Access Compliance Report

Public Rights-of-Way

(Curb Ramps)

Intersection ID: 3937	Main Street: CULLINGFORD_LN	Cross Street: ROYCE_HALL_LN	Location: SE
ADA ID: 4C7A12ABECC0	Ramp Type: BlendTrans2	Initial Pass/Fail: Fail	Overall Compliance: No
Severity Score: 33.75			
Codes/Mitigation Info/Possible Solution		Field Measurements/Component Compliance

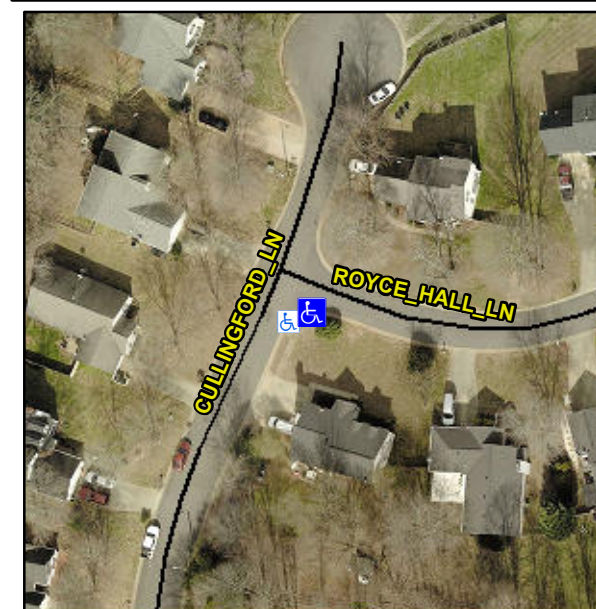
Not Found, R304.5.1, R304.5.3

Compliance	Description	Data	Compliance	Description	Data
N/A	Ramp Length (in)	96.0	Yes	BlendTrans Slope (%)	4.8
No	Ramp Width (in)	39.0	No	BlendTrans XSlope (%)	8.5
N/A	Flare Type LT	N/A	N/A	Flare Type RT	N/A
N/A	Flare Slope LT (%)	N/A	N/A	Flare Slope RT (%)	N/A
N/A	Flare Traversable LT?	N/A	N/A	Flare Traversable RT?	N/A
N/A	Landing Length (in)	N/A	N/A	DWS Provided?	N/A
N/A	Landing Width (in)	N/A	N/A	DWS Contrast?	N/A
N/A	Landing Slope (%)	N/A	N/A	DWS Length (in)	N/A
N/A	Landing X Slope (%)	N/A	N/A	DWS Full Width?	N/A
N/A	Landing Curb? (Y/N)	N/A	N/A	DWS Offset (in)	N/A
N/A	Shared Landing?	N/A			
N/A	Gutter Ponding?	N/A	N/A	Gutter Slope (%)	N/A
N/A	Gutter Lip Ht (in)	N/A	N/A	Gutter X Slope (%)	N/A
N/A	Painted X Walk1?	No	N/A	Painted X Walk2?	N/A
	X Walk 1 Direction	To N		X Walk 2 Direction	N/A
	X Walk 1 Width (in)	N/A		X Walk 2 Width (in)	N/A
	X Walk 1 Slope (%)	0.7		X Walk 2 Slope (%)	N/A
	X Walk 1 X Slope (%)	5.1		X Walk 2 X Slope (%)	N/A

N/A	Ramp inside XWalk1?	N/A	N/A	Ramp inside XWalk2?	N/A
	Road Slope (%)	5.1		Clear Space?	N/A
	Road X Slope (%)	0.7	N/A	Clear Space to XWalk (in)	N/A
N/A	Any Obstructions?	N/A	N/A	Storm Grate/Utility Hazard?	N/A
	Obstruction Type			Storm Grate/Utility Type	
		N/A			N/A
			Yes	Surface Condition? (G/P)	Good
			No	Curb Slope (%)	13.3

Remove & Replace Curb Ramp With Two New Directional Ramps or Equivalent.
